Groundwater Transfer Review Summary Form

Transfer/PA # T- <u>13677</u>		
GW Reviewer Michael Thoma	Date Review Completed: _0 <u>5</u>	/06/2021
Summary of Same Source Review:		
☐ The proposed change in point of appropriation is not within 2110(2).	n the same aquifer as per OAR (690-380-
Summary of Injury Review:		
☐ The proposed transfer will result in another, existing water water to which it is legally entitled or result in significant interf 690-380-0100(3).	,	
Summary of GW-SW Transfer Similarity Review:		
☐ The proposed SW-GW transfer doesn't meet the definition	of "similarly" as per OAR 690-3	80-2130.
This is only a summary. Documentation is attached and should basis for determinations.	be read thoroughly to understo	and the

Transfer Application: T-13677

Transfer Review Map

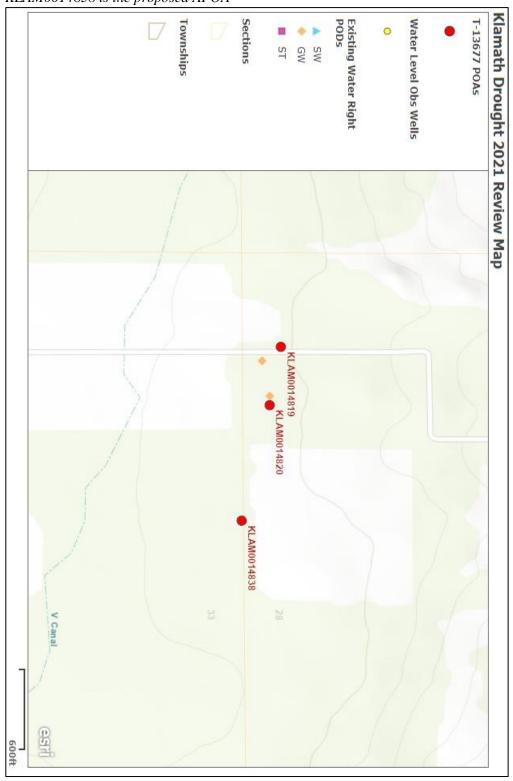
KLAM0014189 is authorized on Permit G-12450 KLAM0014820 is authorized on Permit G-12450 and Cert. 27103 KLAM0014838 is the proposed APOA
